**Gateway to Hunts Point FDC:
Freight Electric Vehicle Charging Hub and Welcome Center RFP
Project # 10693**

**Addendum # 4
8/19/2024**

APPENDIX 11: GENERAL SITE CONDITIONS

Figure 9

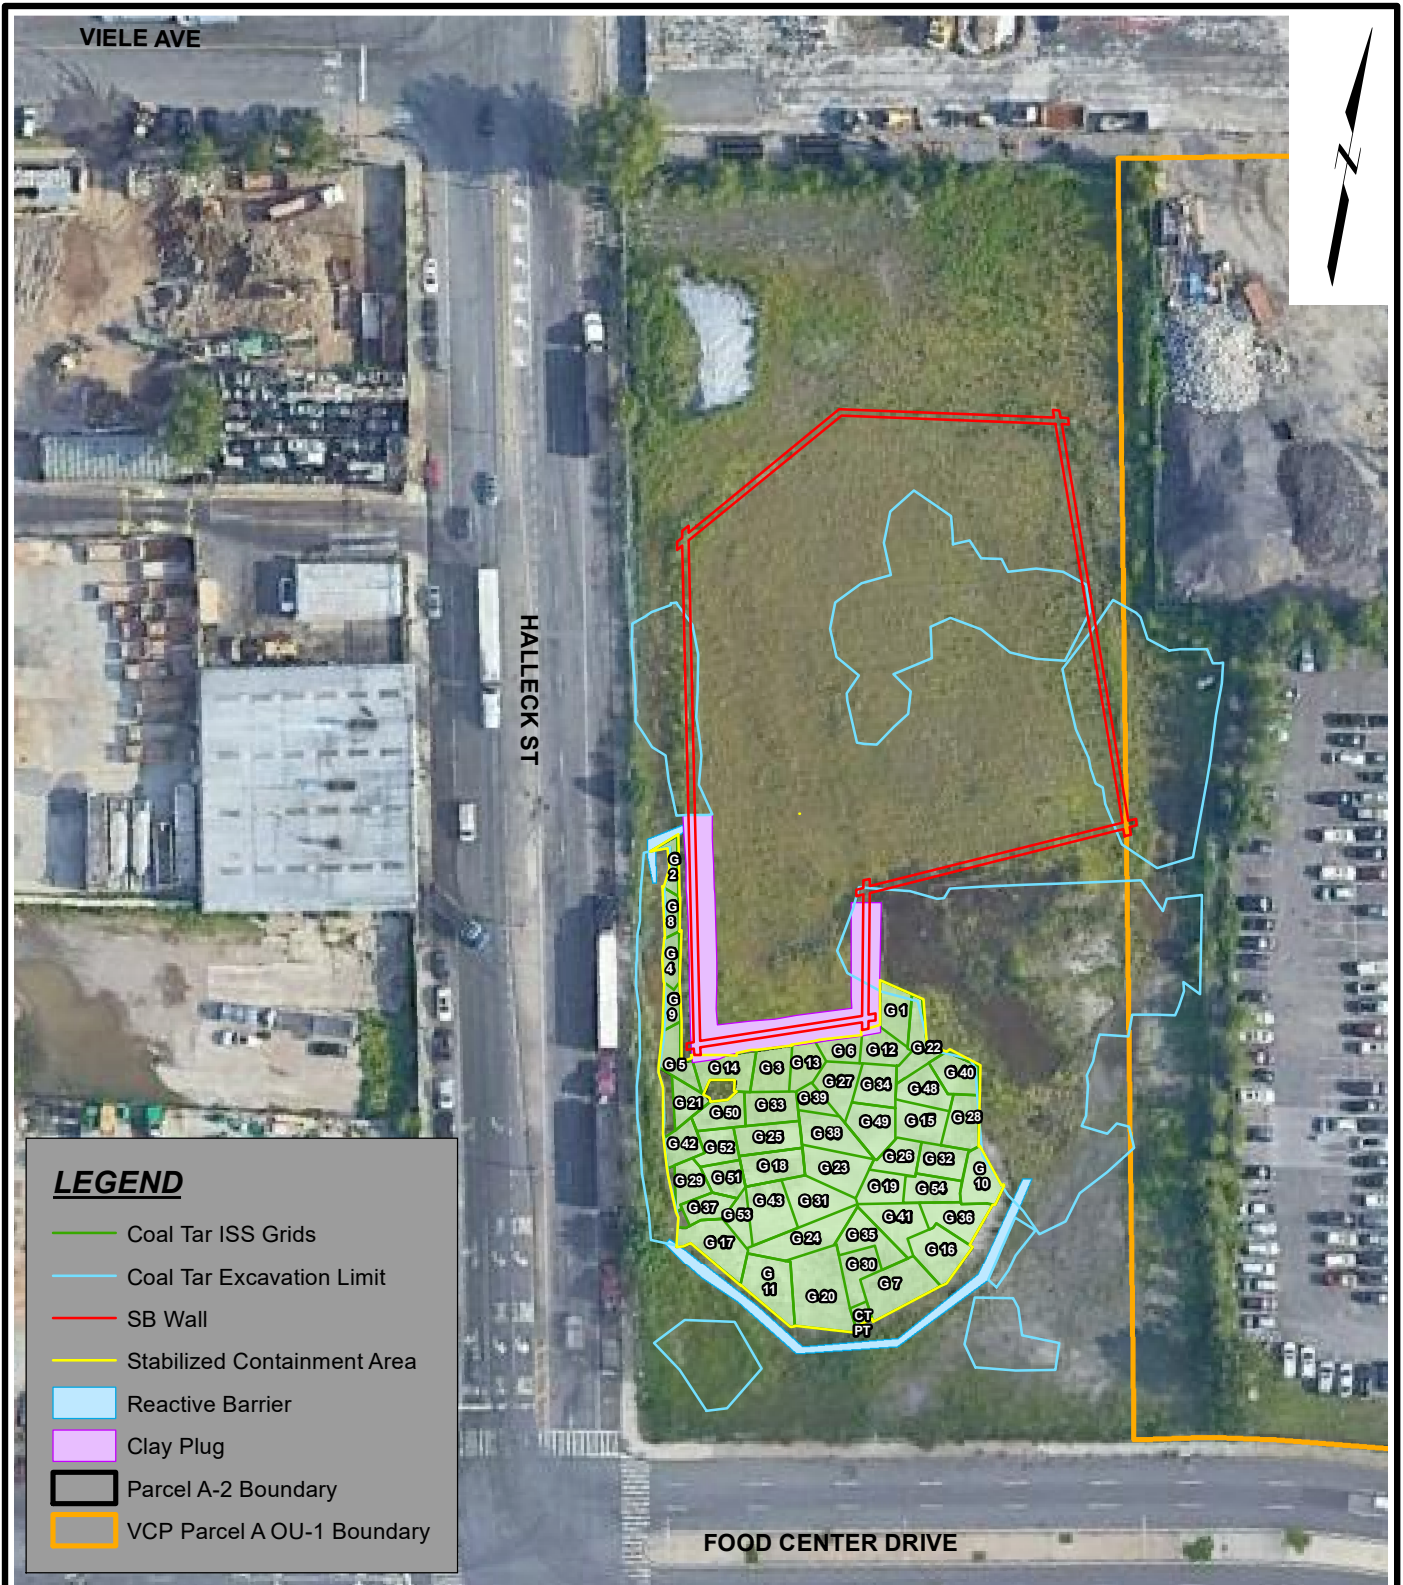
1. Excavation of coal tar waste, in the areas labeled "Coal Tar Excavation Limit" on Figure 9 attached hereto.
2. Solidification (in-situ stabilization or "ISS") of a large mass of buried waste in the central portion of the property, in the areas labeled "Coal Tar ISS" and "Stabilized Containment Area" on Figure 9 and labeled "Stabilized Containment Area" on Figure 15, attached hereto.

3. Installation of a soil bentonite ("SB") wall (a soft/soil-mix wall that includes fine grain material to maintain low permeability) surrounding a majority of the ISS material, labeled "SB Wall" on Figure 9, Figure 15, and Figure A and Figure C, attached hereto. The SB wall is approximately 4 feet thick and extends to the lower clay layer (approximately 11-15 feet below grade). The purpose of the SB wall is to prevent groundwater from contacting the ISS material.

Figure C

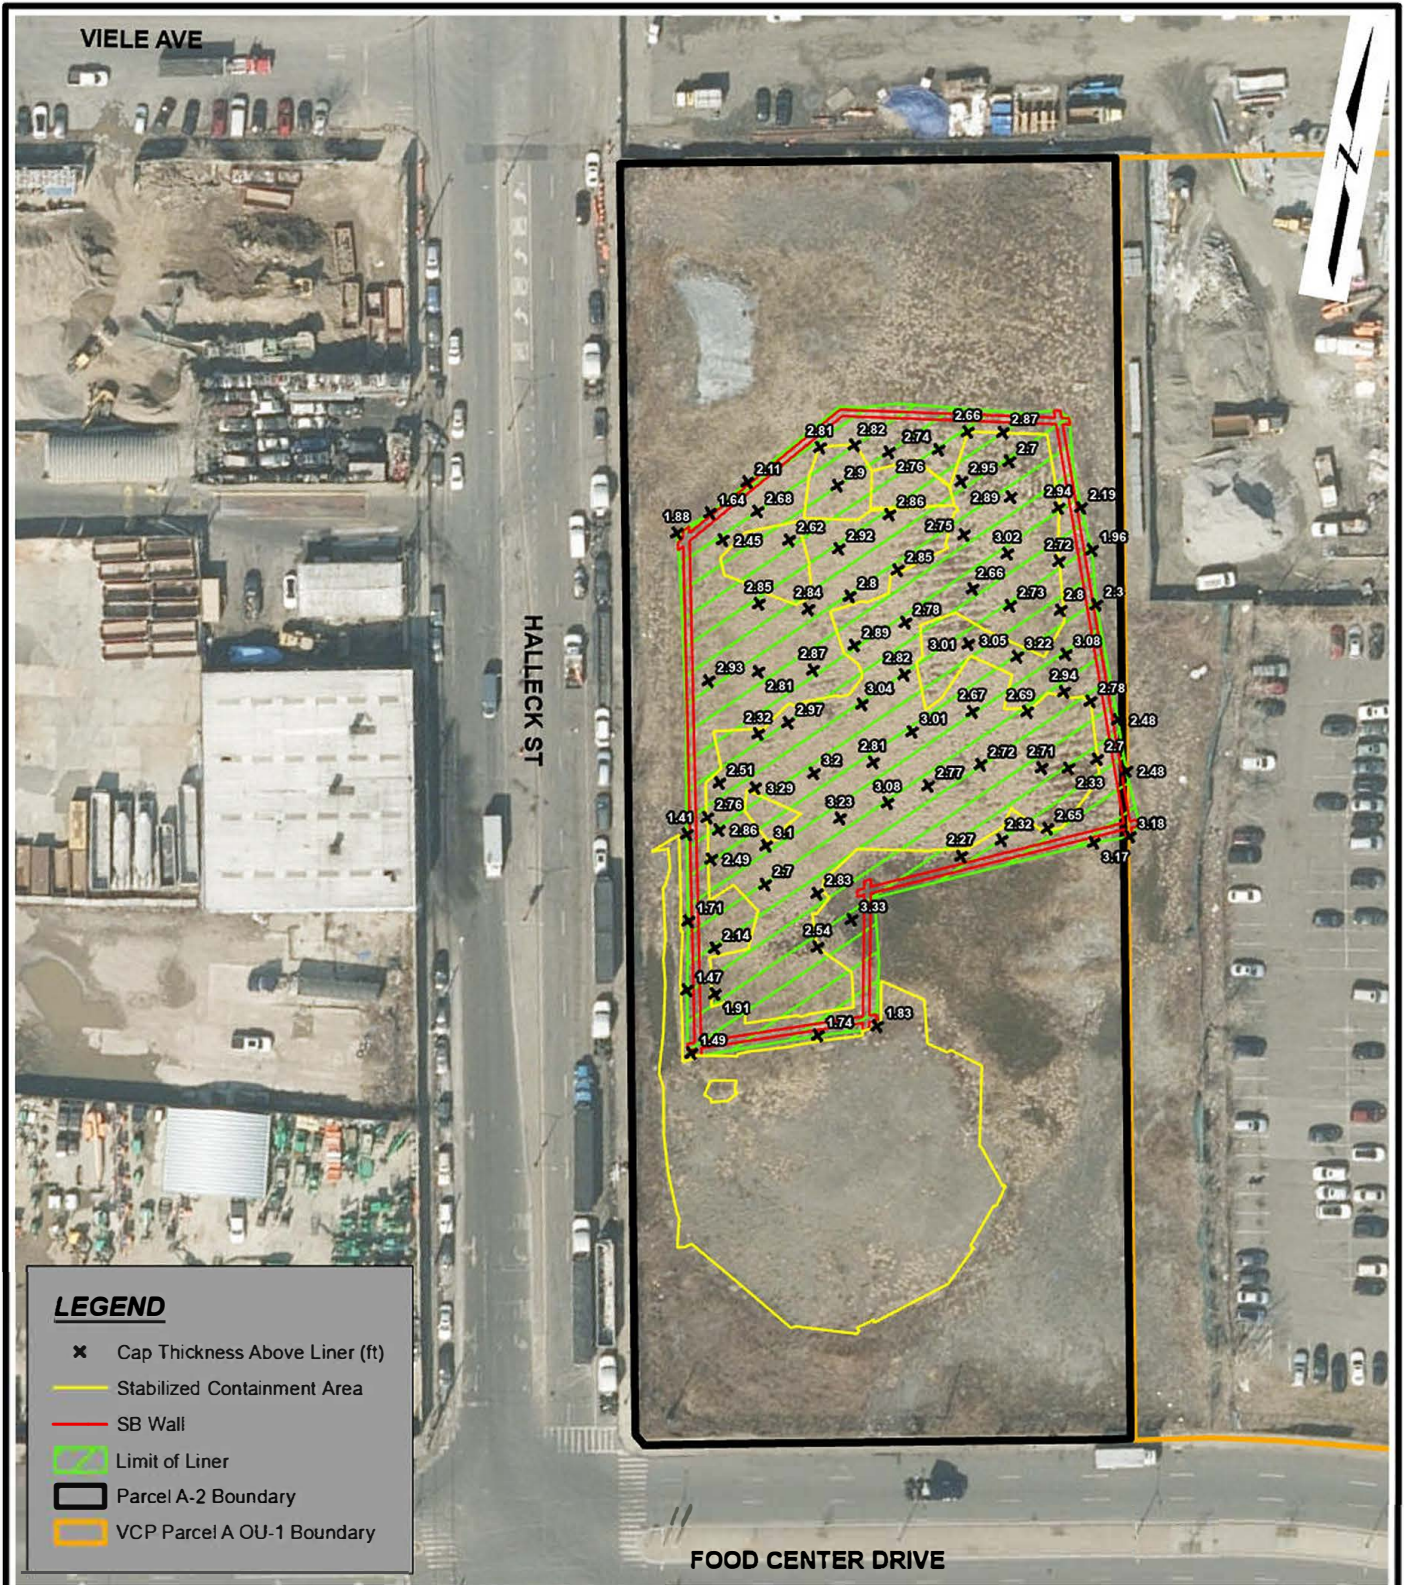
4. Installation of a PVC liner (40 mil) over the entire area inside of the SB wall from end to end and also extending over the wall itself, in the area labeled "Limit of Liner" on Figure 15 and Figure C.

- Above the liner is a layer of clean, tested, and approved backfill material that brings the total thickness of cover material above the solidified surface to approximately 2 feet. The thickness of the fill above the liner has been surveyed in various locations to show the thickness when it was placed, as shown in Figure C. It is
